P 535965

**ON-SITE SEWAGE DISPOSAL SYSTEM
 HOWARD COUNTY HEALTH DEPARTMENT
 BUREAU OF ENVIRONMENTAL HEALTH**

SUBDIVISION: Lime Kiln Valley II LOT NUMBER: 23

ADDRESS: 12889 Lime Kiln Road PROPERTY OWNER: Maple W LC

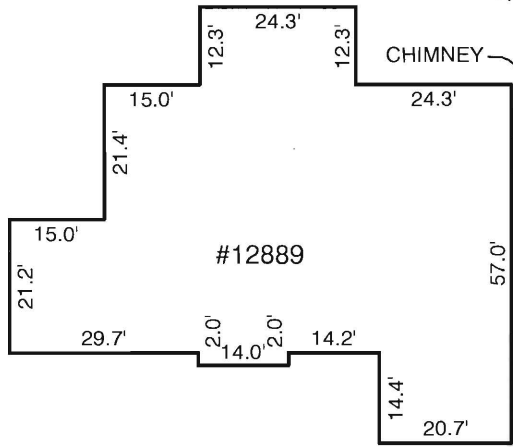
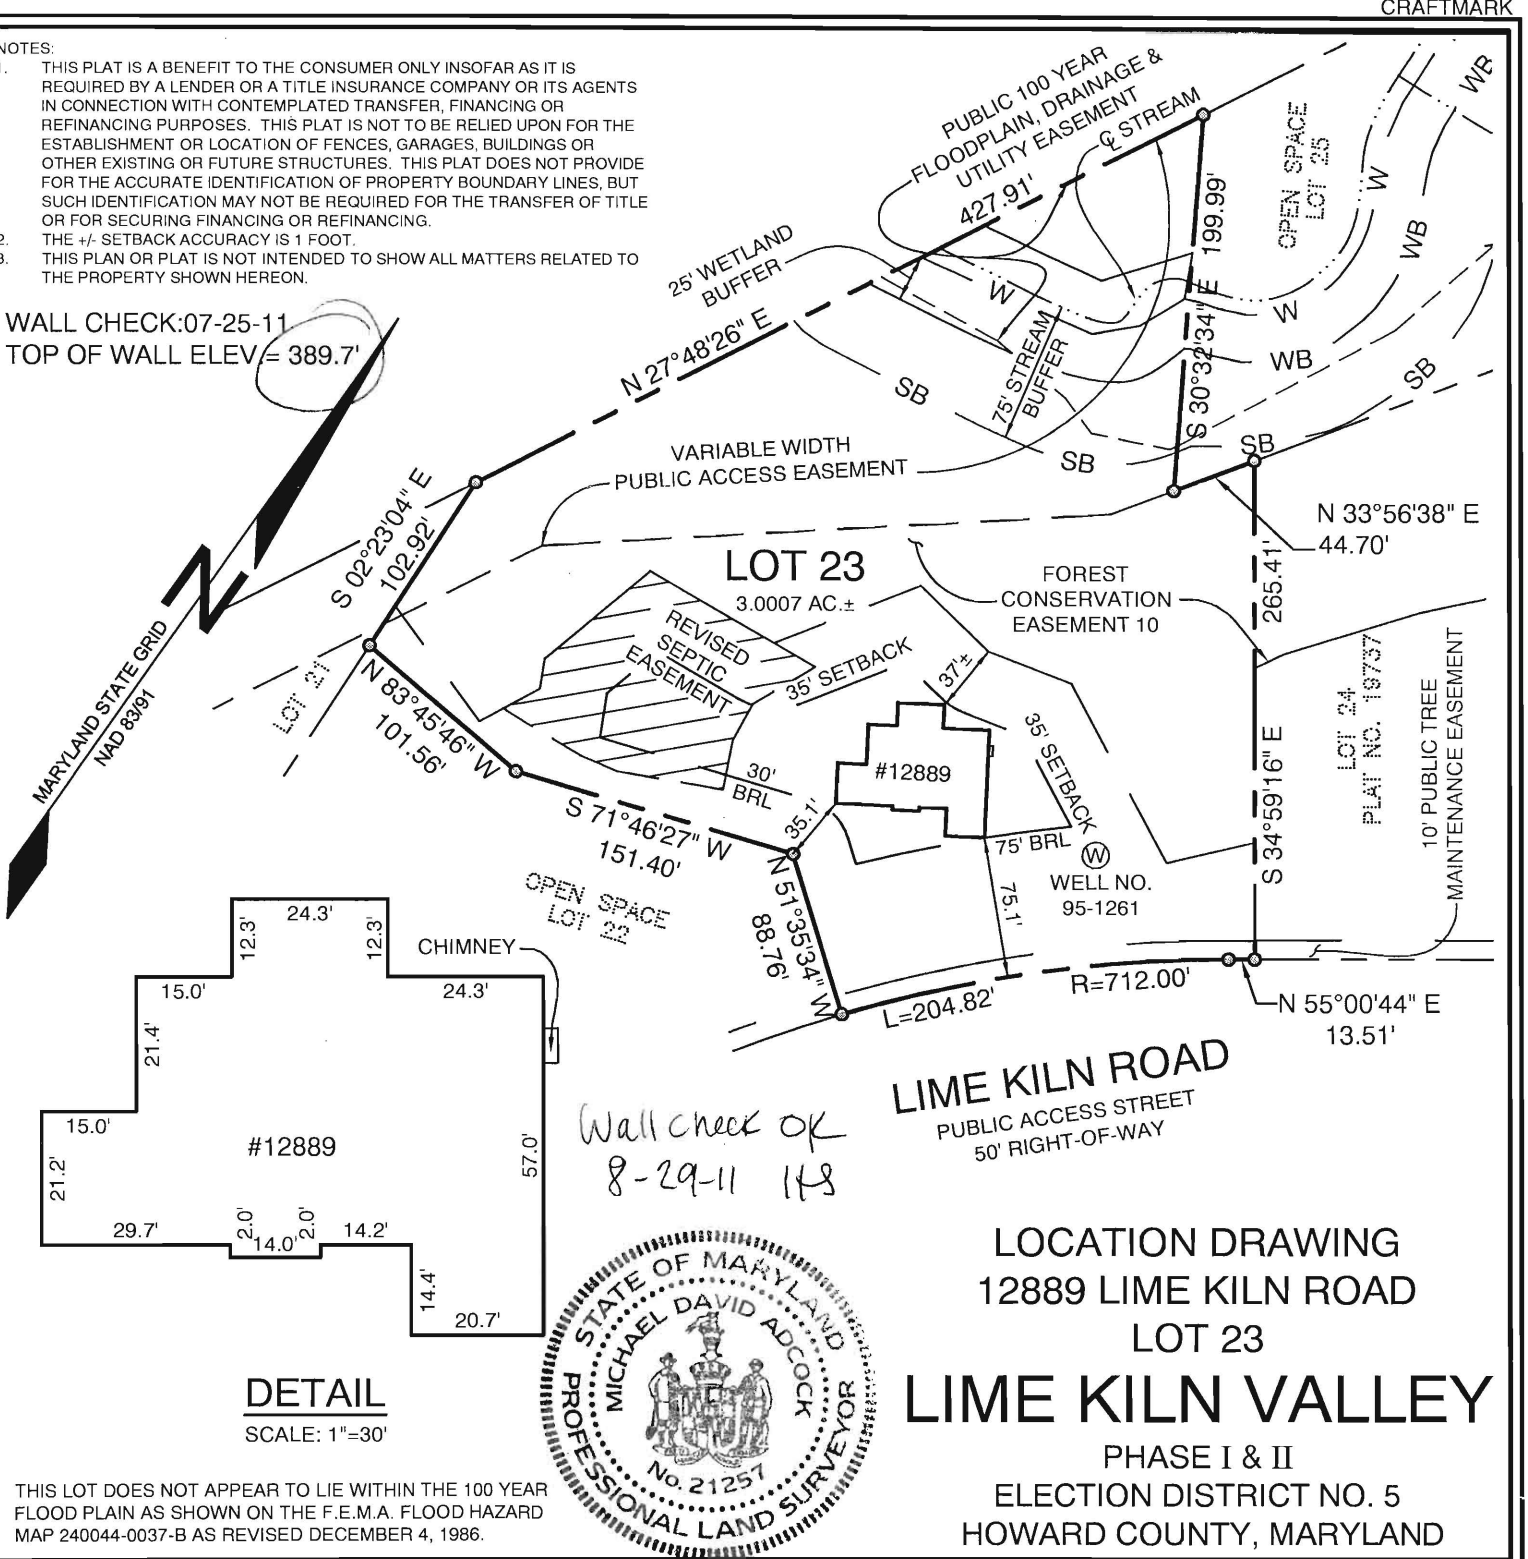
9/26/11 Set S.T. 20' from house - set D box @ highest corner of SRA closest to back corner of house, install 2 trenches (80', 90') running across SRA. Keep bottoms level. Inlet raised to 3'. (KW)

9/27/11 Tank hole dug. SHC made (KW)
 9/28/11 Tank set lower trench complete. OK to continue (KW)
 9/29/2011 System finished. O.K. to backfill. (KW)
